ADDENDUM NO 2

TO: All Prospective Bidders
DATE: January 31, 2017
PROJECT: Hobart Hall RTUs & HVAC Controls (WP-16-06-03)

title
ROOF PLAN
 dwg. no.
M1H

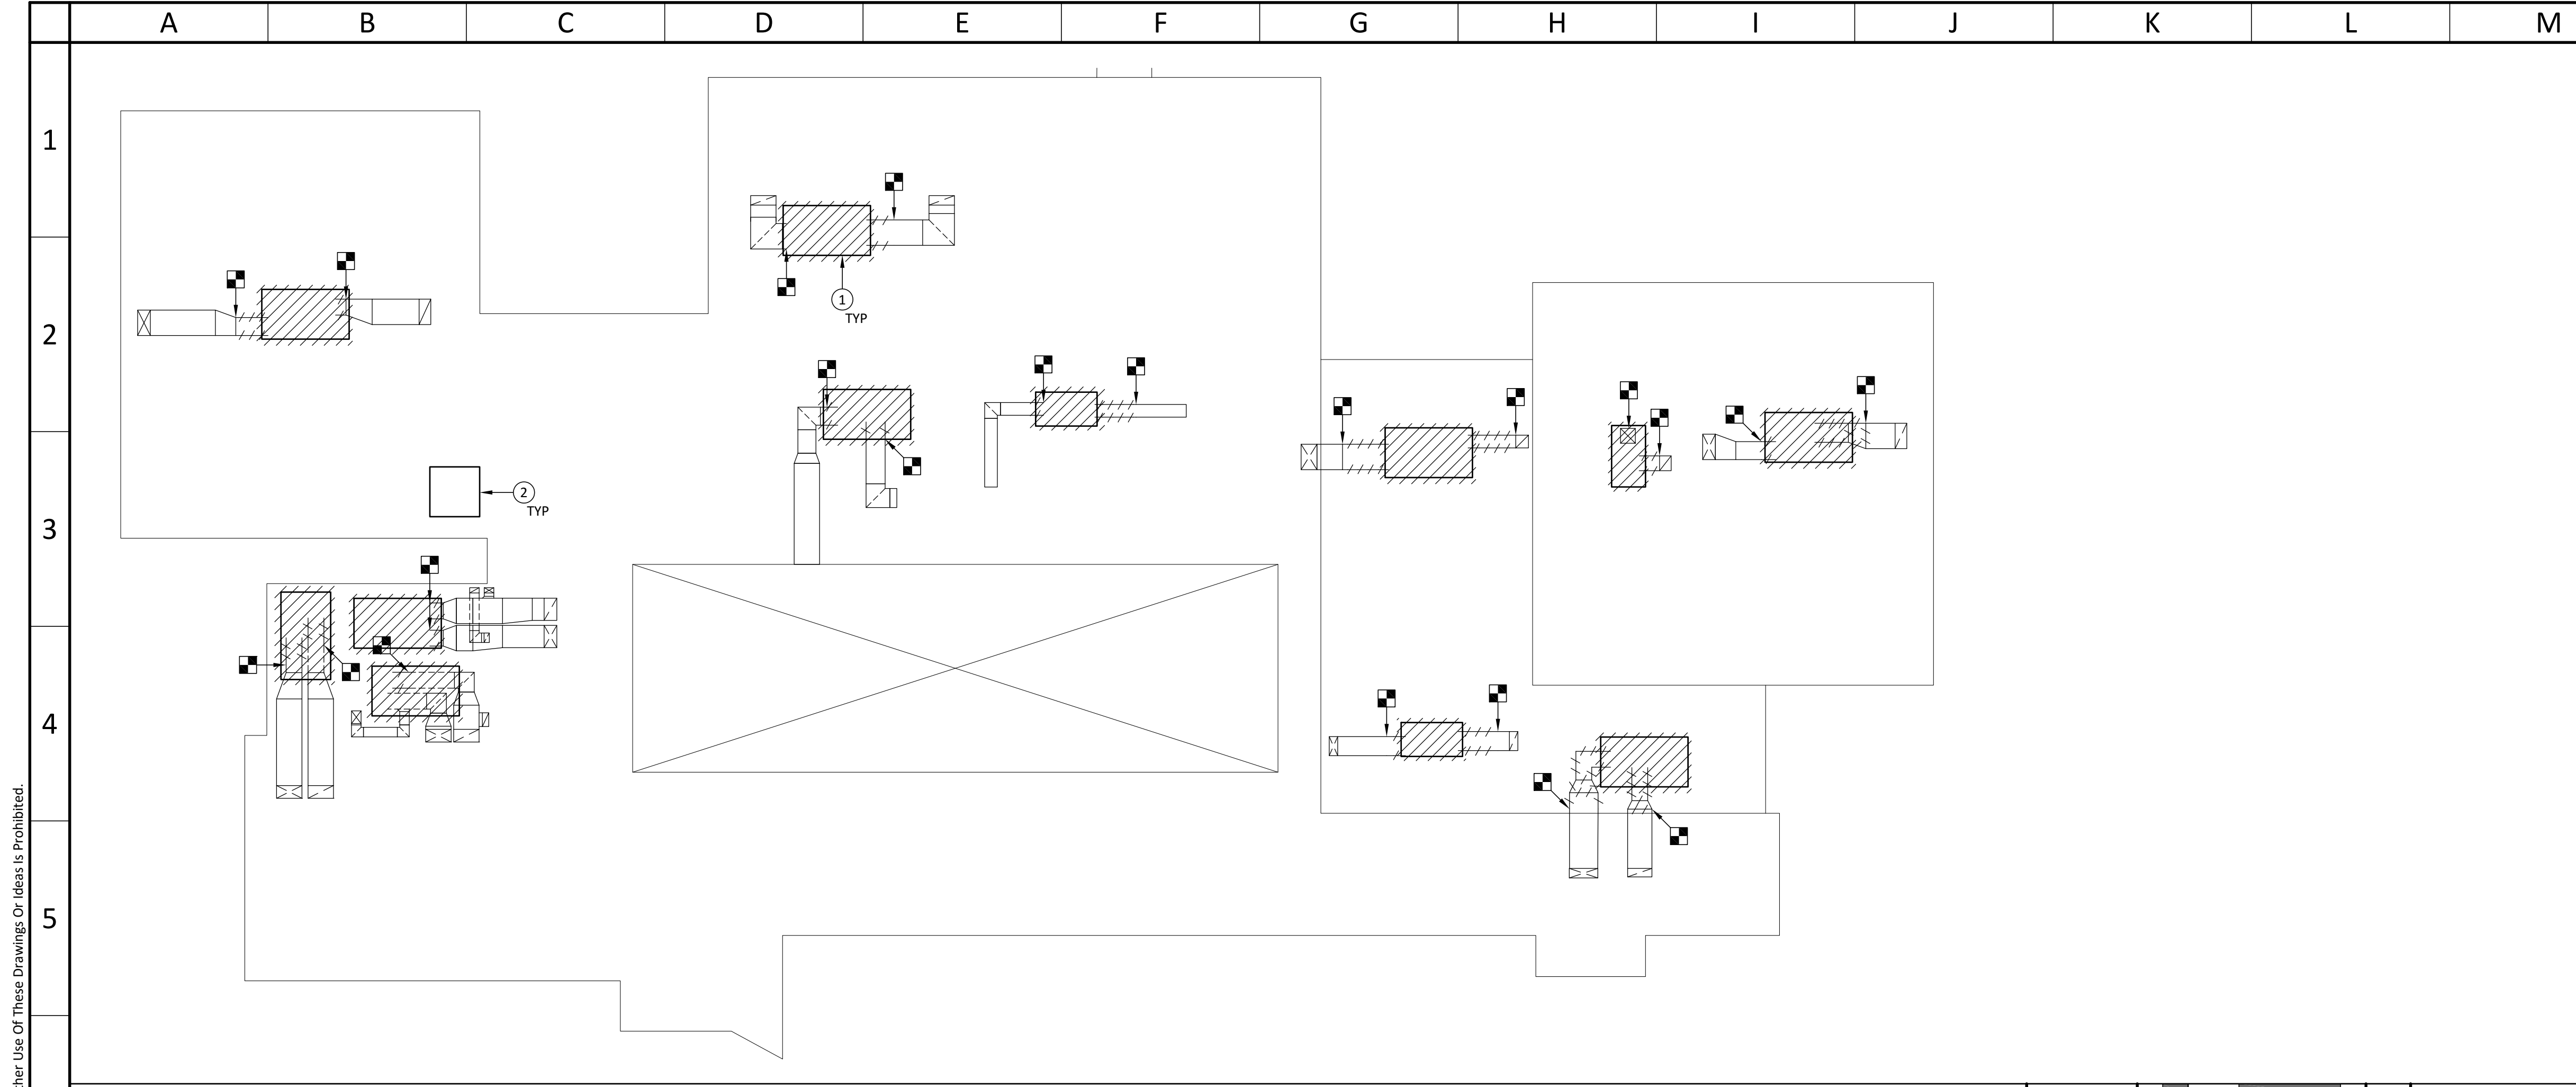
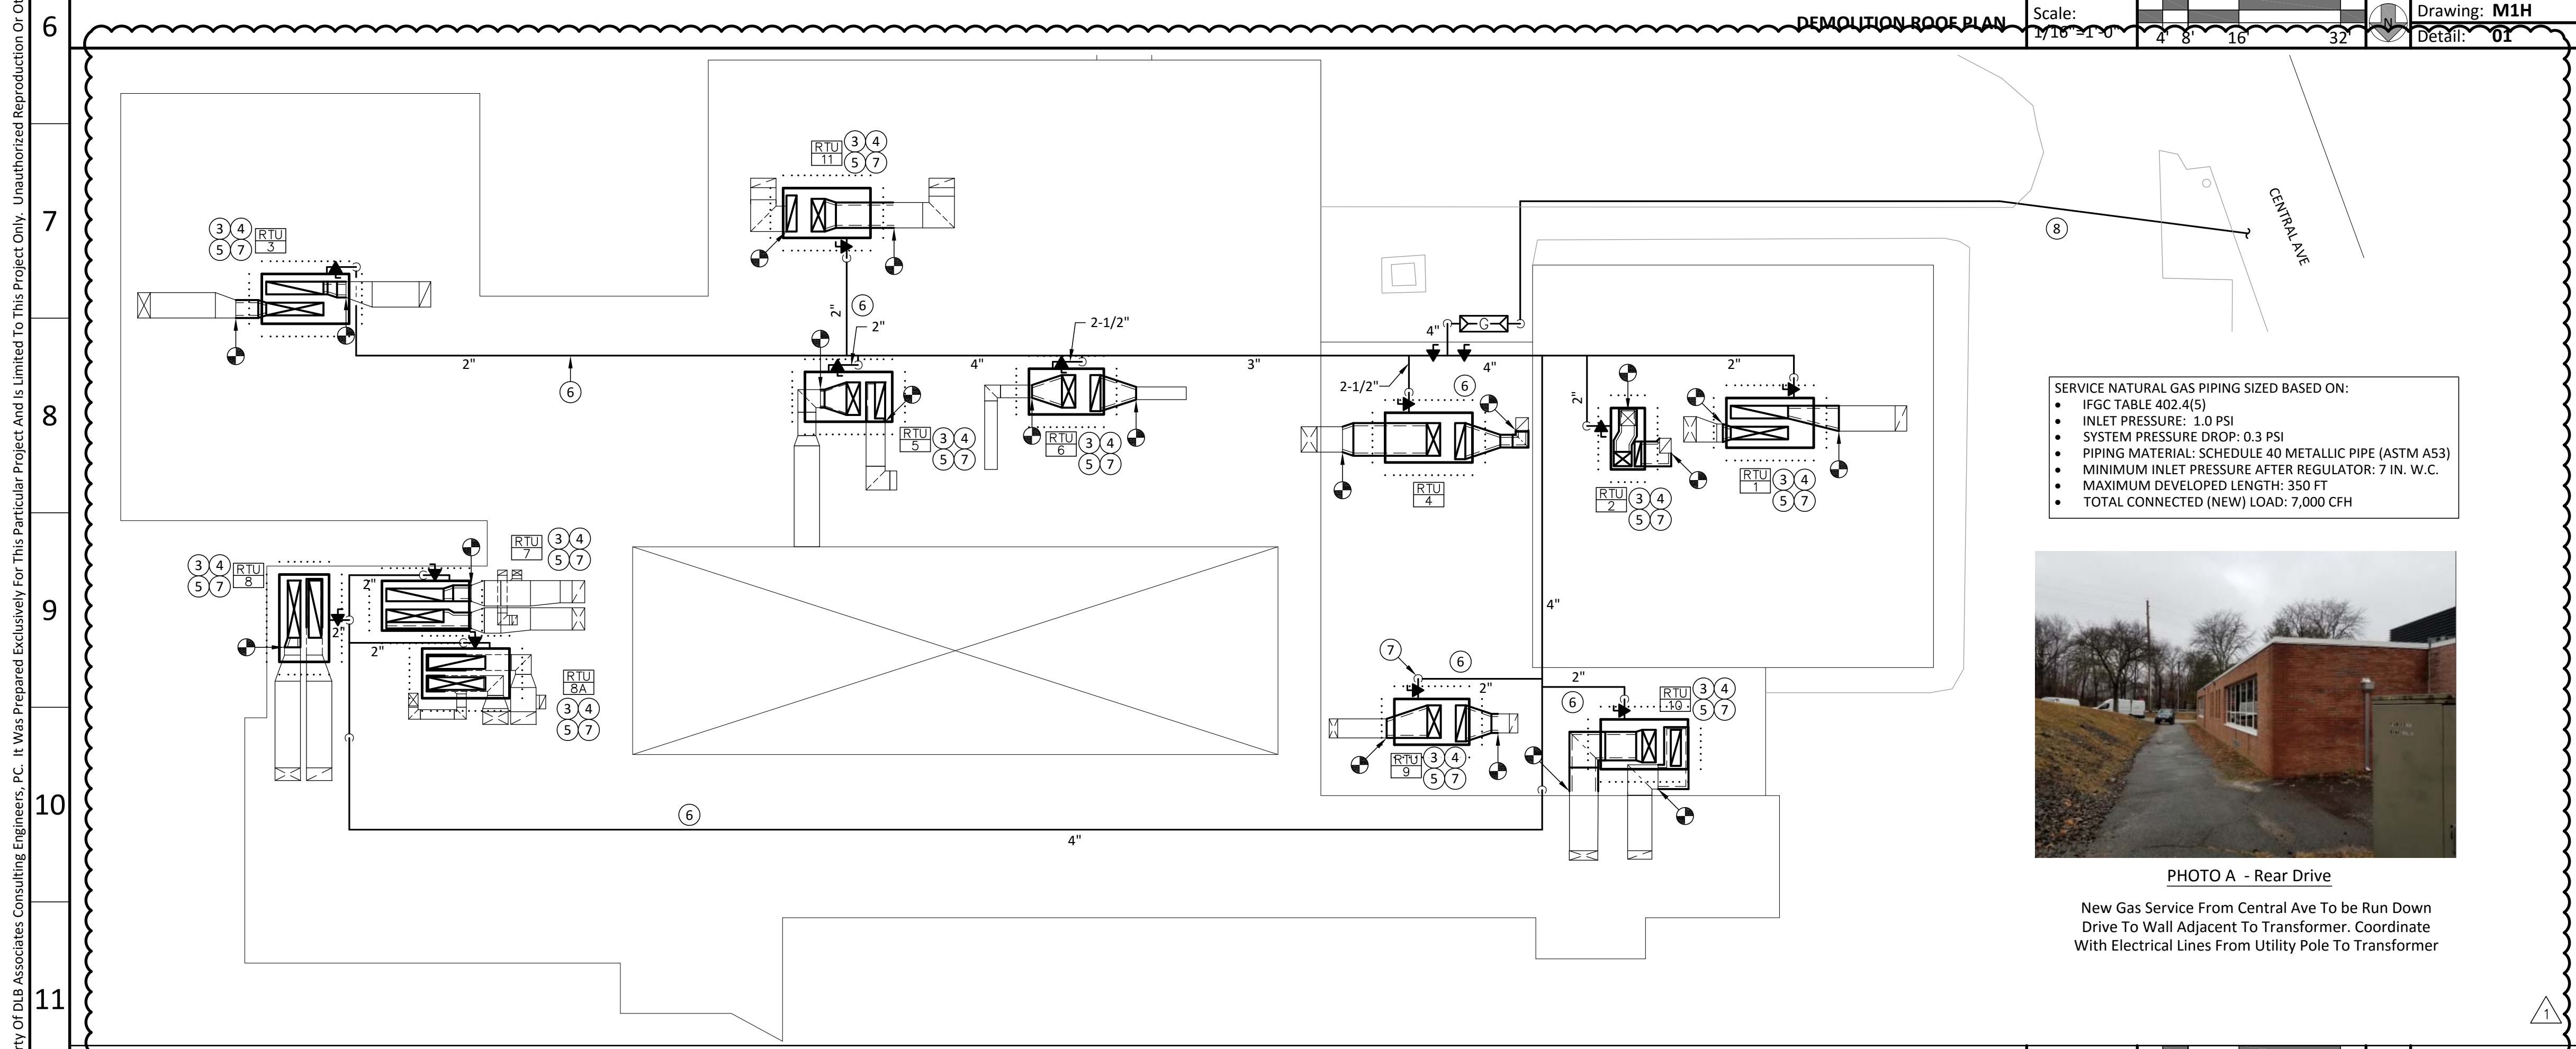
Q. Is acoustical liner required on the new ductwork? Please specify size, if so.

The duct sizes on the plan are internal clear dimensions, note 1 on M1H:

A.: Yes, provide 1-Inch Thick Acoustical Lining In The Supply And Return Duct Of All Air Handling Units Up To 20-Feet from The Fan Discharge.

All Duct Sizes Stated On Plans Are Internal Clear Dimensions. Outer Dimensions Of Internally Lined Ductwork Shall Be Increased Accordingly.
